ADDENDUM No. 2

ITB No. 4754

Fiber and Conduit Construction for the Ann Arbor/Ypsilanti Broadband Project

Map showing connection points and path to Data Center.

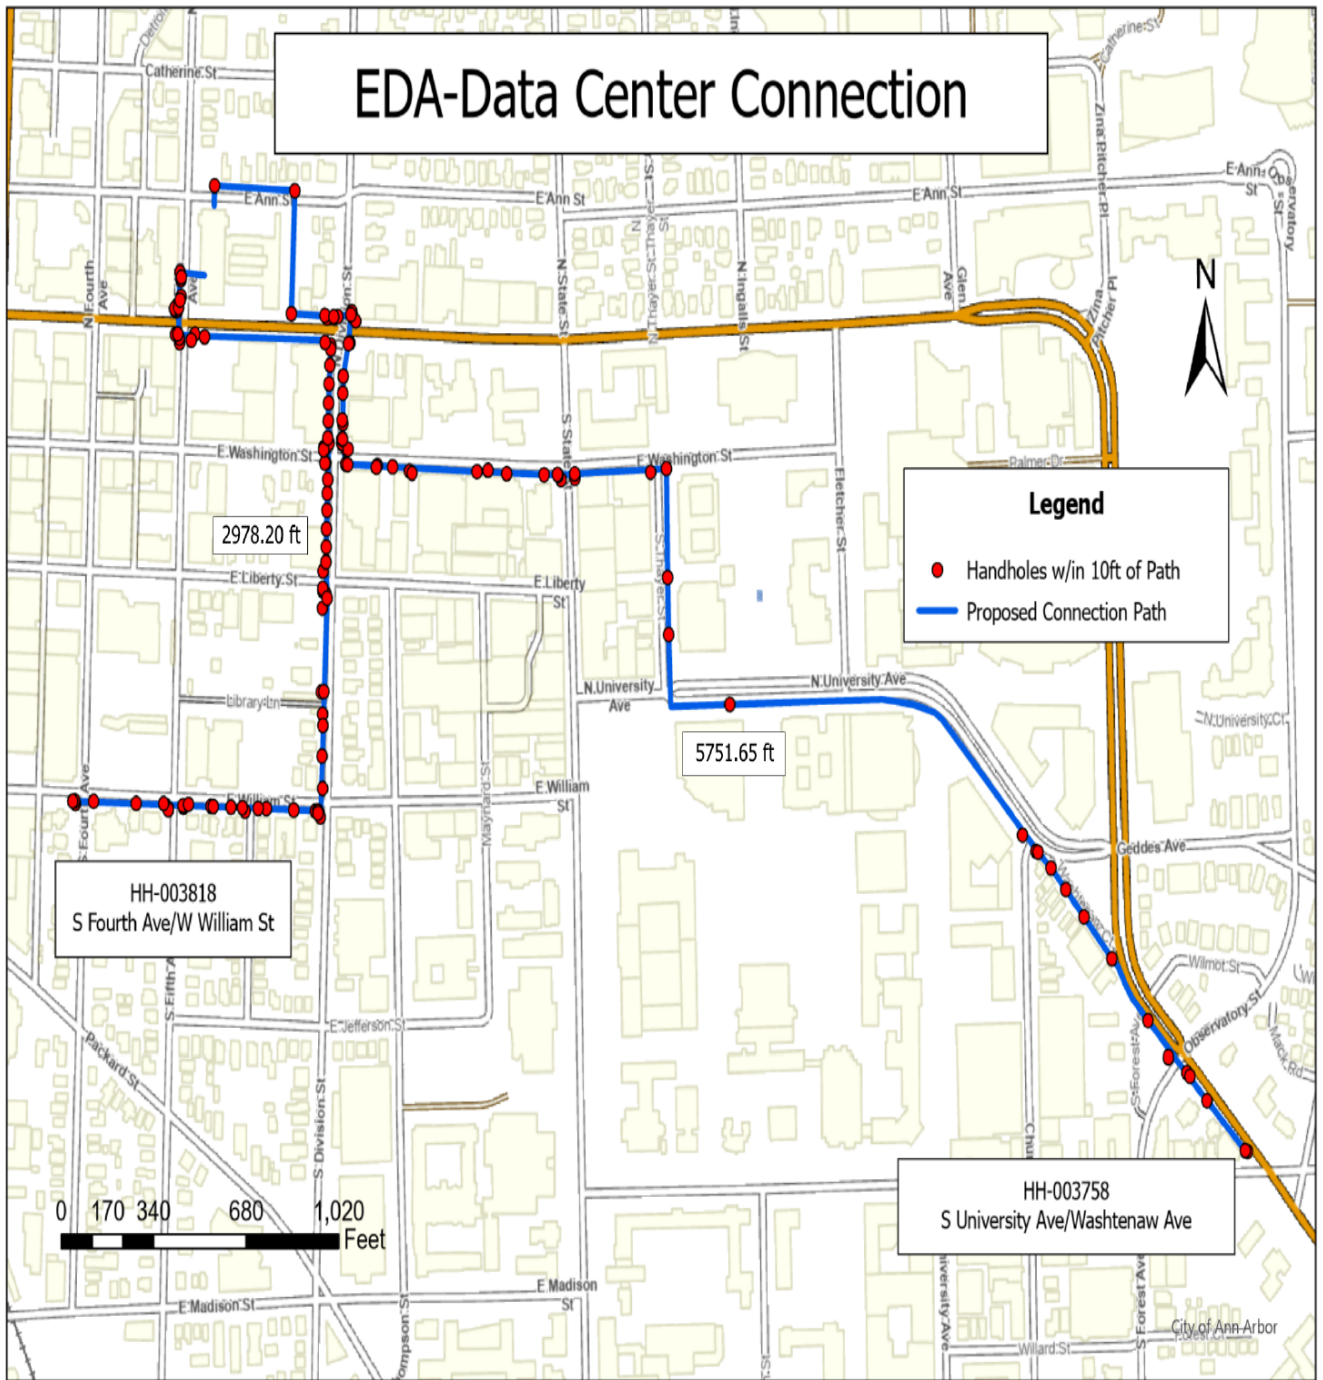
Question 14: How many total existing handhole (HH) locations will be intercepted for the new fiber build, and how many of these locations will require upgrades to accommodate the new ducts?

Question 25: Do we have drawings of where the fibers are going from last handholes at each end?

Answer 14: The new conduit system will intercept each handhole and utilize existing conduit back to the data center. The handholes and conduit was installed within the last 2 years. See attached map on page Addendum-1-8.

Answer 25: Yes, please see attached map on page Addendum-1-8
